NONCONFORMANCE - REPORT LOG & STATUS BOOK

1. PROJECT NO. 7220

1. Project Name Midland Units 1 and 2		Job No. 7220		19. No. 586	20. Page 1 of 25		
2. Unit(s) 2	3. Drawing/Part No. M-613 sh 1	Rev 3/F2	4. Item Description Nuclear Class 2 Pipe spool 2-GCB-006-S613-7	5. Item Location Containment Dome Unit 2

PLAN AT ELEV. 624.0"

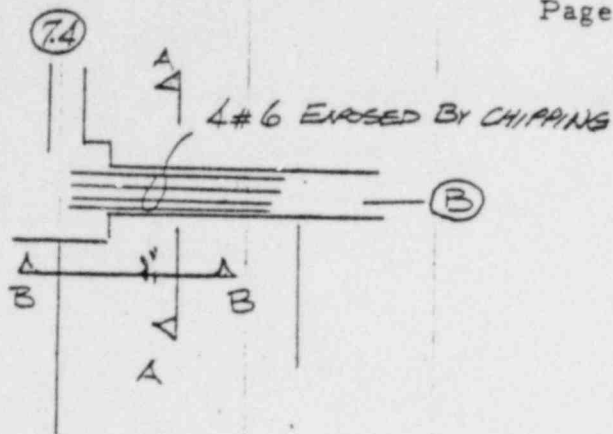
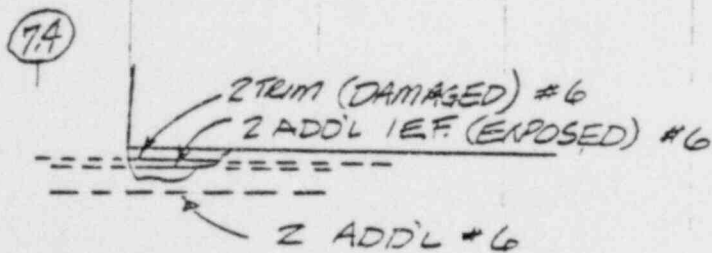
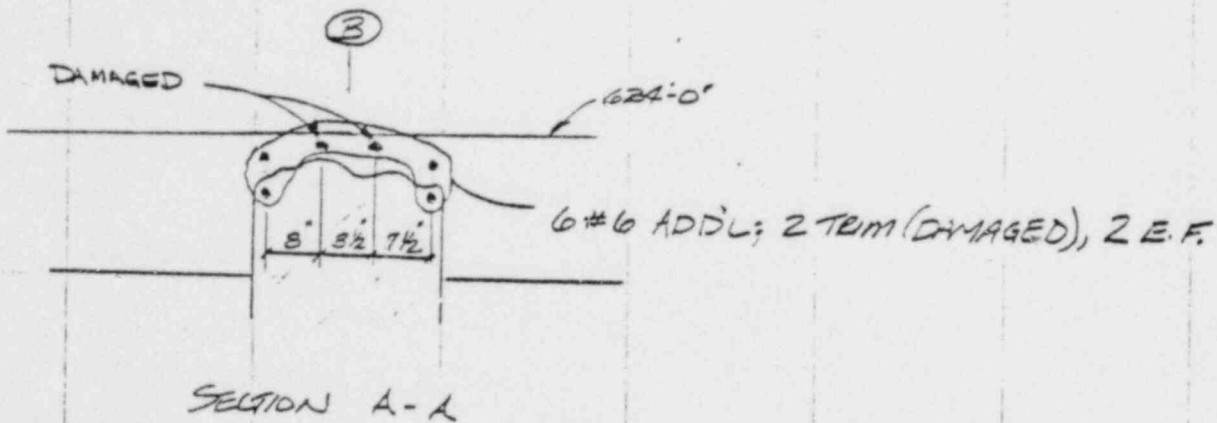
16. Nonconforming Condition: Note #3 on Drawing 7220-C-202, Rev. 5 states: "Slab dowels to match slab reinforcing unless noted otherwise."  Contrary to the above, 1 #6 dowel at Elev. 624'0", 12'0" west of 6.2 on "A" line wall is missing.  Hold pending final disposition. Q list #1.203. 1 QC Hold Tags applied.			24. Disposition Concurrence REWORK <input type="checkbox"/> REJECT <input type="checkbox"/> REPAIR <input checked="" type="checkbox"/> USE AS IS <input type="checkbox"/>  E.S. Valenzano 11/15/76 PROJECT FIELD ENGINEER DATE J.A. [Signature] 11-5-76 PROJECT ENGINEER DATE J.P. [Signature] 11-16-76 PROJECT CONSTR QC ENGINEER DATE  AUTHORIZED INSPECTOR DATE

21. Routing <input checked="" type="checkbox"/> TO FIELD ENGINEERING <input type="checkbox"/> TO OTHERS (SPECIFY)		22. <input type="checkbox"/> Field Engineering Disposition <input checked="" type="checkbox"/> FIELD ENGINEERING RECOMMENDED DISPOSITION TO PROJECT ENGINEERING				
4 #6 diagonal dowels (1T&B E.S.) are existing for the temporary opening. Note #4 of Detail 7 on C-140 specifies that the diagonals are not required. Repair as follows, use diagonal dowel for a replacement dowel by straightening the diagonal dowel so that a 6" non-contact lap splice can be maintained with the replacement bar as required by Detail 7 on C-140. J.D. Desmond 10-8-76 [Signature]
